SI2019-008

Regarding 8DB 355 013-651 (T1736) → 8DB 355 025-381 (T2638) / 8DB 355 025-391 (T2639)

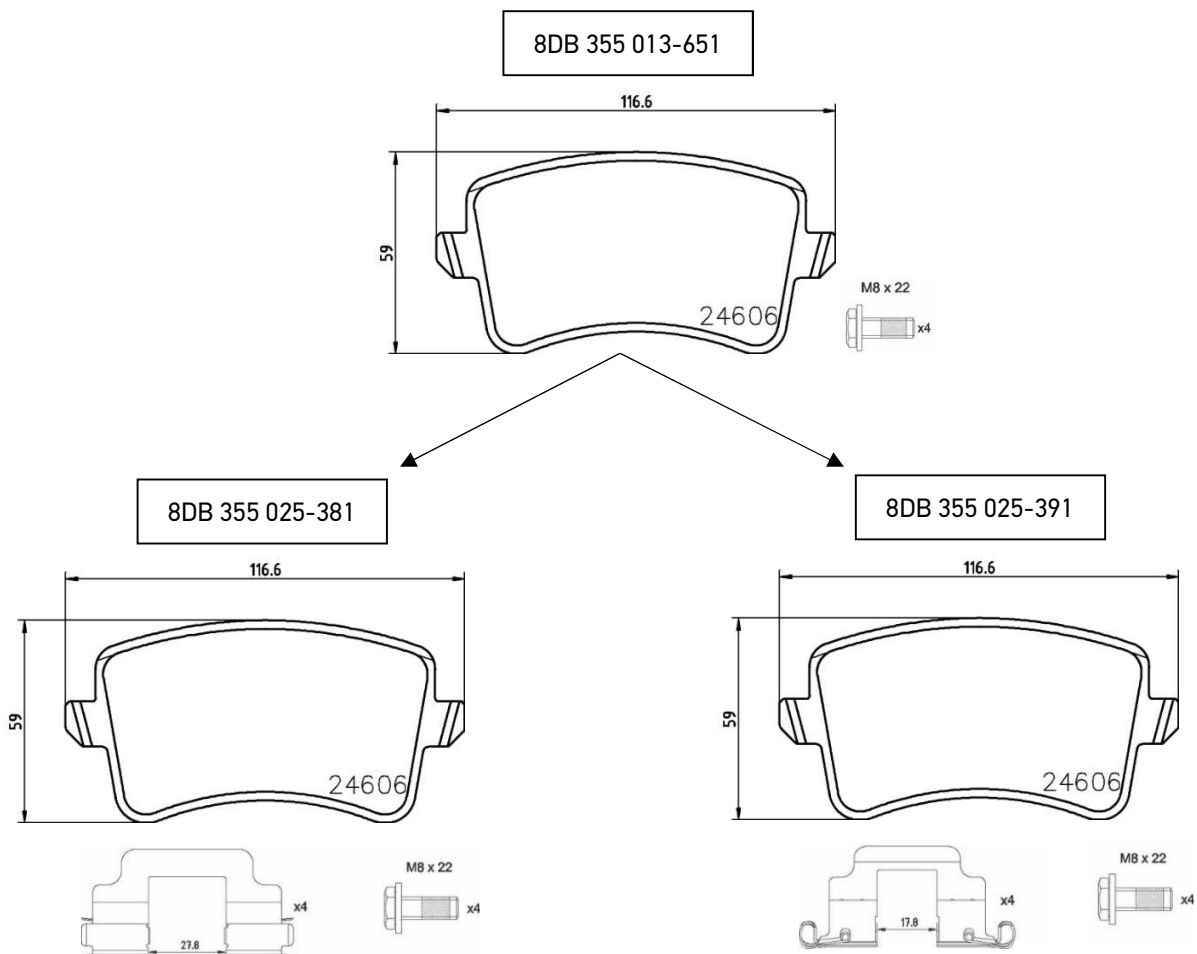
Depending on the vehicle specification two different accessory kits are needed. In order to meet those requirements, the 8DB 355 013-651 has been split into two different part numbers, so that customers can easily choose the right part number for their needs.

8DB 355 013-651 will be replaced by 8DB 355 025-381 (incl. sliding shims with about 28 mm gap) and 8DB 355 025-391 (incl. sliding shims with about 18 mm gap). Please see the differences in the pictures below.
